Access Compliance Report

Public Rights-of-Way

(Curb Ramps)

Intersection ID: 9260	Main Street: MILES_CT	Cross Street: MULBERRY_AV	Location: SE
ADA ID: EB6ED07A49B8	Ramp Type: Perp	Initial Pass/Fail: Fail	Overall Compliance: No
Severity Score: 8.75			
Codes/Mitigation Info/Possible Solution		Field Measurements/Component Compliance

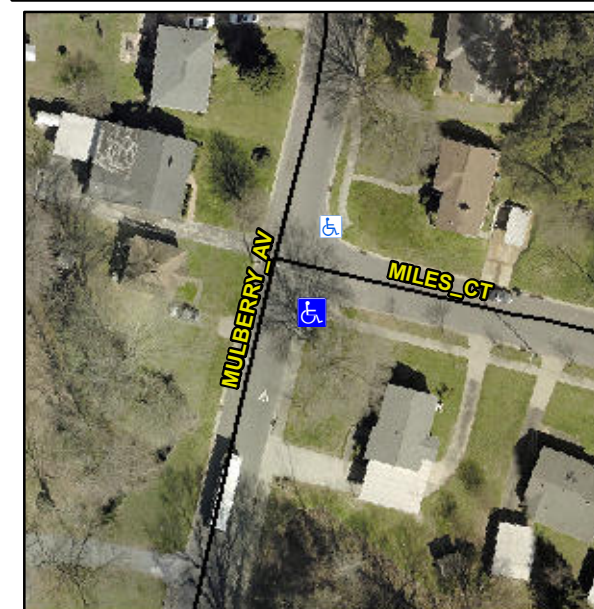
Not Found, R304.5.1

Compliance	Description	Data	Compliance	Description	Data
N/A	Ramp Length (in)	28.0	Yes	Ramp Slope (%)	6.5
No	Ramp Width (in)	47.0	Yes	Ramp XSlope (%)	0.7
N/A	Flare Type LT	N/A	N/A	Flare Type RT	N/A
N/A	Flare Slope LT (%)	N/A	N/A	Flare Slope RT (%)	N/A
N/A	Flare Traversable LT?	N/A	N/A	Flare Traversable RT?	N/A
N/A	Landing Length (in)	N/A	N/A	DWS Provided?	N/A
N/A	Landing Width (in)	N/A	N/A	DWS Contrast?	N/A
N/A	Landing Slope (%)	N/A	N/A	DWS Length (in)	N/A
N/A	Landing X Slope (%)	N/A	N/A	DWS Full Width?	N/A
N/A	Landing Curb? (Y/N)	N/A	N/A	DWS Offset (in)	N/A
N/A	Shared Landing?	N/A			
N/A	Gutter Ponding?	N/A	N/A	Gutter Slope (%)	N/A
N/A	Gutter Lip Ht (in)	N/A	N/A	Gutter X Slope (%)	N/A
N/A	Painted X Walk1?	No	N/A	Painted X Walk2?	N/A
	X Walk 1 Direction	To N		X Walk 2 Direction	N/A
N/A	X Walk 1 Width (in)	N/A	N/A	X Walk 2 Width (in)	N/A
	X Walk 1 Slope (%)	5.6		X Walk 2 Slope (%)	N/A
	X Walk 1 X Slope (%)	4.5		X Walk 2 X Slope (%)	N/A

Remove & Replace Entire Ramp.
